TDECQ update: Comments on proposals to add threshold adjustment

IEEE 802.3cd plenary, O'Hare airport, March 2018
Jonathan King, Finisar

Contents: notes on the proposals to add threshold adjustment to TDECQ*

^{*}Related to comments against 802.3cd Draft 3.1: 97, 98, 99, 102, 104

Slide 6

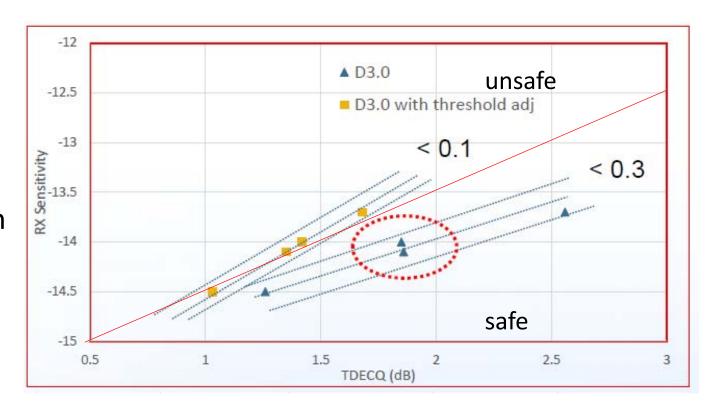
Refers to a hole in the current draft but talks about guard bands.

- It should be noted that IEEE never specifies guard bands, since these would be specific to a particular implementation, the parameter being measured, and the measurement set up.
 - There is no hole in the P802.3cd spec.
- To be compliant, a transceiver must meet specifications over its entire operating range (e.g. over temperature and supply voltage). Guard bands are the responsibility of the manufacturer.

Slide 13 data

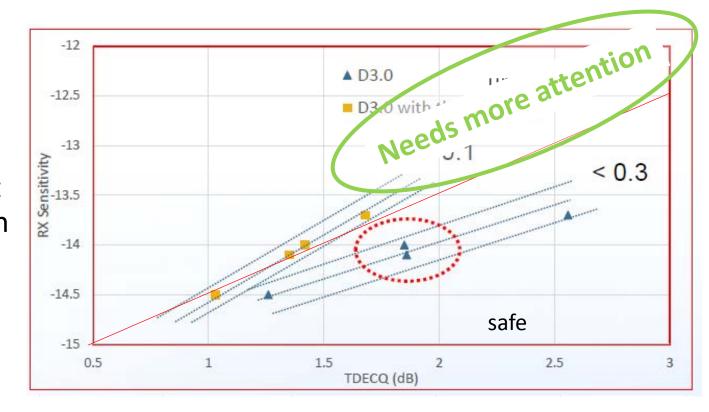
- When thresholds are optimized the slope of Rx sensitivity vs TDECQ is >1
 - This really would be a hole in the spec
- i.e. TDECQ with threshold adjustment underestimates receiver penalty, even though the receiver used has a much longer EQ (10 tap FFE) than the reference EQ
- In contrast, a reference EQ which is representative of the worst case receiver should tend to over-estimate sensitivity penalty (slope of receiver sensitivity vs TDECQ should be ≤1)

TDECQ threshold adjust: impact on allowed sub-eye inequality

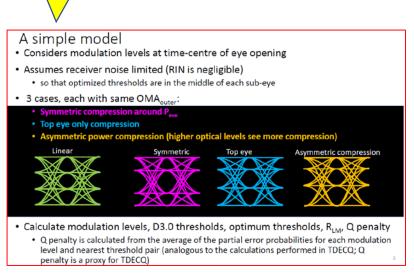
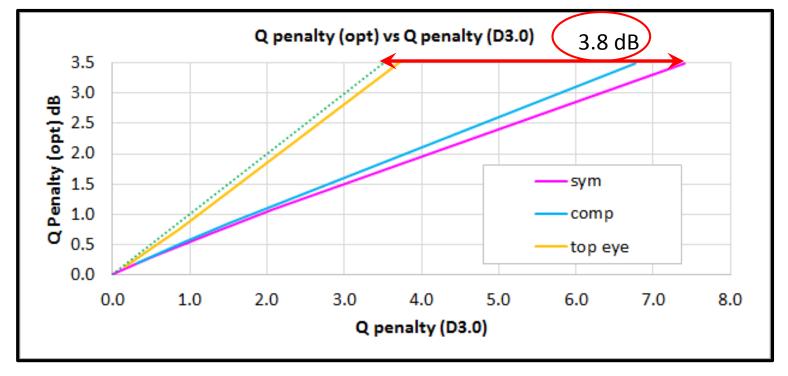
Unlimited threshold adjust ~ doubles the allowed sub eye nonlinearity within the TDECQ limit

Impact of TDECQ threshold adjustment on allowed subeye inequality

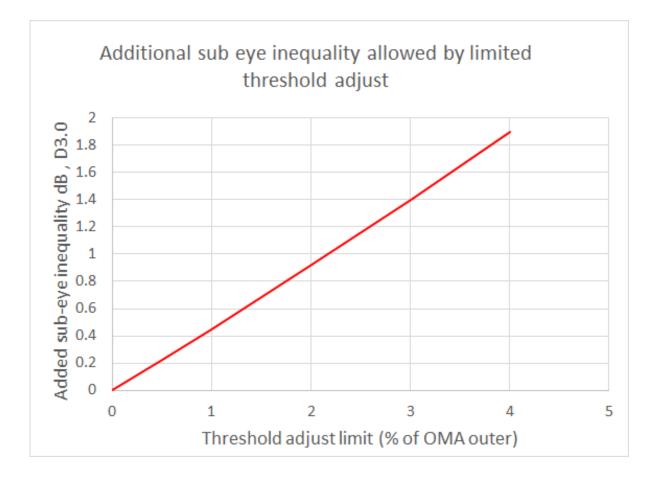
Limited threshold adjustment significantly increases the allowed sub-

eye inequality
